World Forum for Harmonization of Vehicle Regulations**Working Party on Passive Safety****Seventy-fourth session**

UN Regulation No. 14 (Anchorages of safety-belts)**Proposal for Supplement 10 to the 07 Series of Amendments,
Supplement 2 to the 08 Series of Amendments and Supplement
3 to the 09 Series of Amendments to UN Regulation No. 14
(Anchorages of safety-belts) *****Submitted by the expert from International Organization of Motor
Vehicle Manufacturers**

The text reproduced below was prepared by the expert from International Organization of Motor Vehicle Manufacturers (OICA) aiming at adding alternative anchorage positions to UN Regulation No. 14 to enable extended use positions. It is based on GRSP-73-36 distributed at the seventy-third session of the Working Party on Passive Safety (GRSP). The modifications to the existing text of the UN Regulation No. 14 are marked in bold for new or strikethrough for deleted characters.

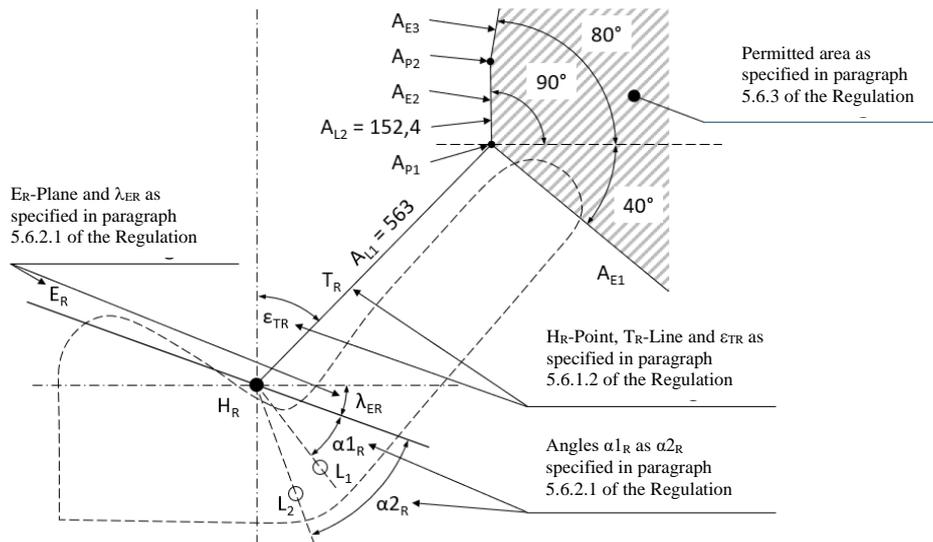
"7.1.1. For vehicles of category M_1 of a total permissible mass not exceeding 2.5 tonnes, if the upper safety-belt anchorage is attached to the seat structure, the effective upper safety-belt anchorage shall not be displaced during the test forward of a transverse plane passing through the R point and point C of the seat in question (see Figure 1 of Annex 3 to this Regulation)

For vehicles other than mentioned above, the effective upper safety-belt anchorage shall not be displaced during the test forward of a transverse plane inclined 10° in forward direction and passing through the R point of the seat.

When using the seat(s) in extended use positions specified in paragraph 6.1.2. of this Regulation, the effective upper safety-belt anchorage shall not be displaced during the test forward of plane B_{E2} (see Figure 4 of Annex 3 to this Regulation)

"Figure 3
Areas of location of effective belt anchorages according to paragraph 5.6.2. and 5.6.3. of this Regulation for extended use positions

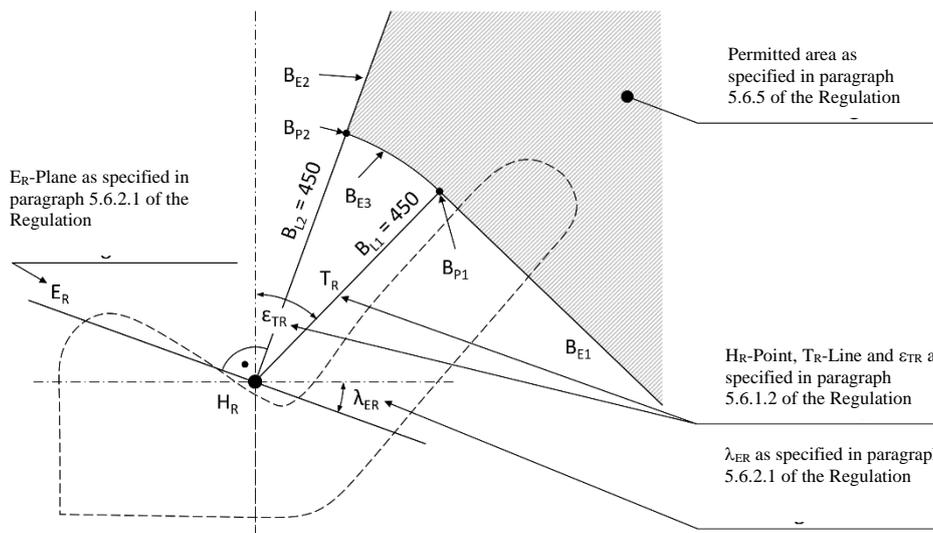
5.6.3. Location of the effective upper belt anchorages (see Figure 3 of Annex 3)

The position of the effective upper belt anchorage point(s) shall be within the permissible area shown in Figure 3 of Annex 3 to this Regulation starting from the H_R -point.

Starting from the H_R -point, the permissible area for the effective upper belt anchorage point(s) is determined with the following segment distances and planes:

A_{L1} A segment of the torso line T_R measured in an upward direction from H_R and 563 mm long and ending in the point A_{P1} ;

A_{L2} segment distance of 152.4 mm length, measured vertically upwards from the A_{P1} point and ending in the point A_{P2}

A first plane A_{E1} , inclined backwards by 40° from the horizontal, is created backwards from point A_{P1} .

A second plane A_{E2} is created perpendicular to the longitudinal centre plane of the seat between points A_{P1} and A_{P2} .

A third plane A_{E3} , inclined horizontally by 80° forwards, is created backwards from point A_{P2} .

The permissible area for the effective upper belt anchorage point(s) is located behind the three planes A_{E1} , A_{E2} and A_{E3} .

Annex 3, insert new Figures 3 and 4, to read:

Figure 4
Permitted area of location for upper effective belt anchorages according to paragraph 5.6.5. of this Regulation for other use positions than normal ones

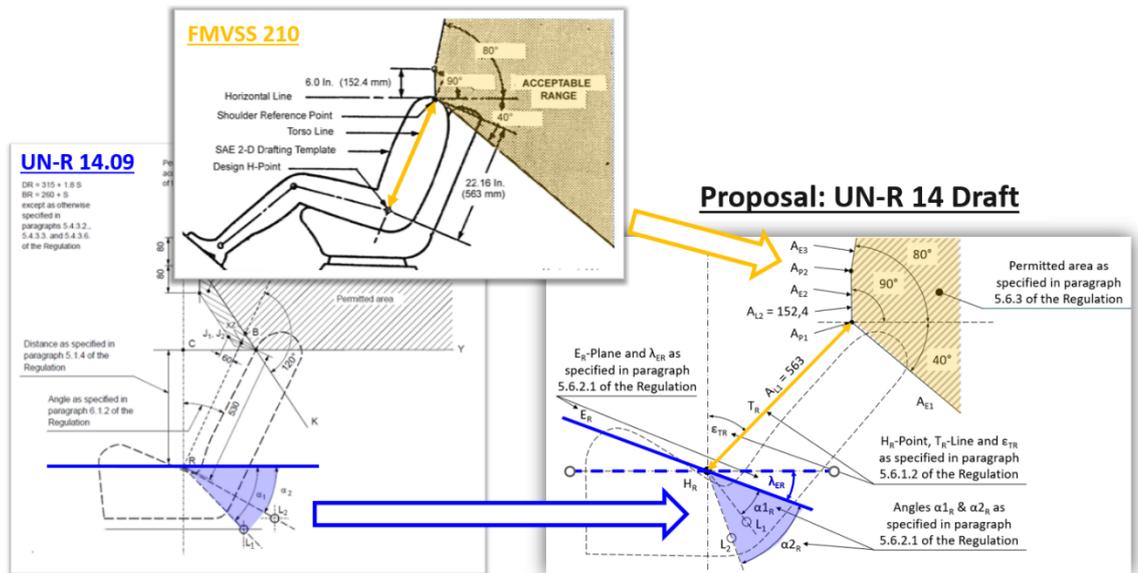
During the test referred to in sub-paragraph (a) and (b), the effective upper belt anchorage point(s) shall be within a permissible area specified in Figure 4 of Annex 3 of this Regulation. For the purpose of this test, the seats may also be in extended use positions as described in paragraph 6.1.2. of this Regulation.

Based on the H_R -point, determine the permissible area shown in Figure 4 of Annex 3 to this Regulation for the effective upper belt anchorage point(s) during the test with the following segment sections and planes:

B_{L1} A segment of the torso line T_R measured in an upward direction from H_R and 450 mm long, ending with the point B_{P1}

B_{L2} A segment distance of 450mm length, measured from the H_R -point perpendicular to the E_R -plane upwards, ending with the point B_{P2}

A first plane B_{E1} is created backwards perpendicular to the torso line T_R and perpendicular to the longitudinal centre plane of the seat at point B_{P1} .

A second plane B_{E2} is created upwards perpendicular to the E_R -plane and perpendicular to the longitudinal centre plane of the seat at point B_{P2} .

A shell surface B_{E3} is created with a radius of 450mm in the H_R -point between the points B_{P1} and B_{P2} perpendicular to the longitudinal centre plane of the seat.

The effective upper belt anchorage point(s) shall not move below or in front of the planes B_{E1} and B_{E2} as well as shell surface B_{E3} during the test."
